STATE OF WASHINGTON
DEPARTMENT OF ECOLOGY

19-NWP-016

Re: Sensitivity Analysis on Recharge Rates for the *200-EA-1 Operable Unit Waste Site RCRA Facility Investigation/Corrective Measures Study and Remedial Investigation/Feasibility Study Work Plan* (200-EA-1 Work Plan), Draft A, DOE/RL-2016-58

Figure 3-10. Central Plateau Inter Area Native Vegetation Recharge Scenario (DOE/RL-2016-58)

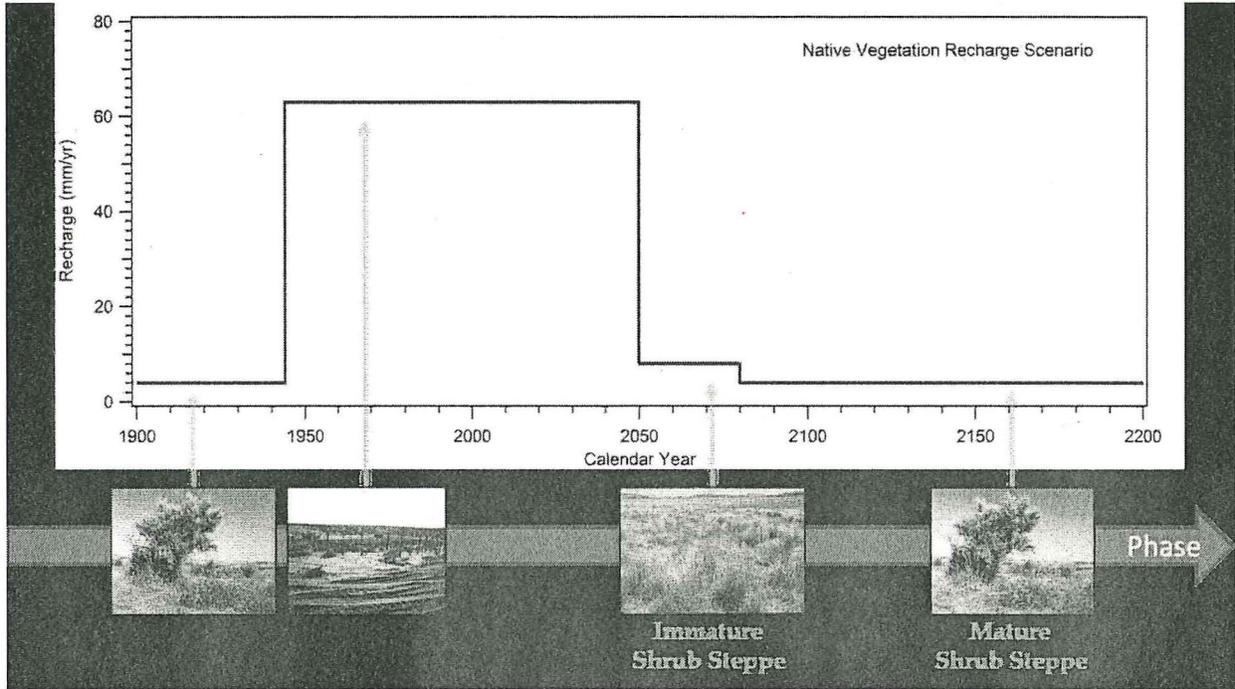
The enclosed diagram from the 200-EA-1 Work Plan (Figure 3-10) lists the recharge rates in millimeter (mm)/year for four different plant community phases. The recharge rate for "Mature Shrub Steppe" is set at 4 mm/year, the same rate as the "pre-Hanford" community phase. Ecology questions the validity of this value since there has been major destruction of the plant communities and soil horizons in the 200 Area over the past 70 years. Though replanting may be initially successful, invasive species such as cheatgrass are known to compete with native shrub communities after fires, which are likely to occur over hundreds of years.

Therefore, Ecology is requesting that USDOE-RL conduct a sensitivity analysis using the proposed Subsurface Transport Over Multiple Phases (STOMP) model to demonstrate the potential impacts of 200-EA-1 OU waste site contamination to groundwater with varying recharge rates for the "Immature Shrub Steppe" and "Mature Shrub Steppe" phases. The STOMP *Sparse Vegetation Evapotranspiration Model for the Water-Air-Energy Operational Mode* (Reference 3) includes an inverse mode to simplify parameter sensitivity analysis. It is unclear why USDOE-RL is avoiding the standard approach that has been used previously at Hanford.

The *Feasibility Study for the Plutonium/Organic-Rich Process Condensate/Process Waste Group Operable Unit: Includes the 200-PW-1, 200-PW-3, and 200-PW-6 Operable Units* (200-PW-1, 3, 6 FS) (Reference 4) performed a sensitivity study for three cribs with a limited number of contaminants. Ecology is proposing to use the same recharge rates used in the 200-PW-1, 3, 6 FS sensitivity analysis with the contaminants identified in the 200-EA-1 Work Plan. Based on the results of the sensitivity analysis, Ecology and USDOE-RL can then discuss appropriate cleanup levels for the 200-EA-1 OU Work Plan

At this point, Ecology will not approve the work plan until it includes the sensitivity analysis on recharge rates.
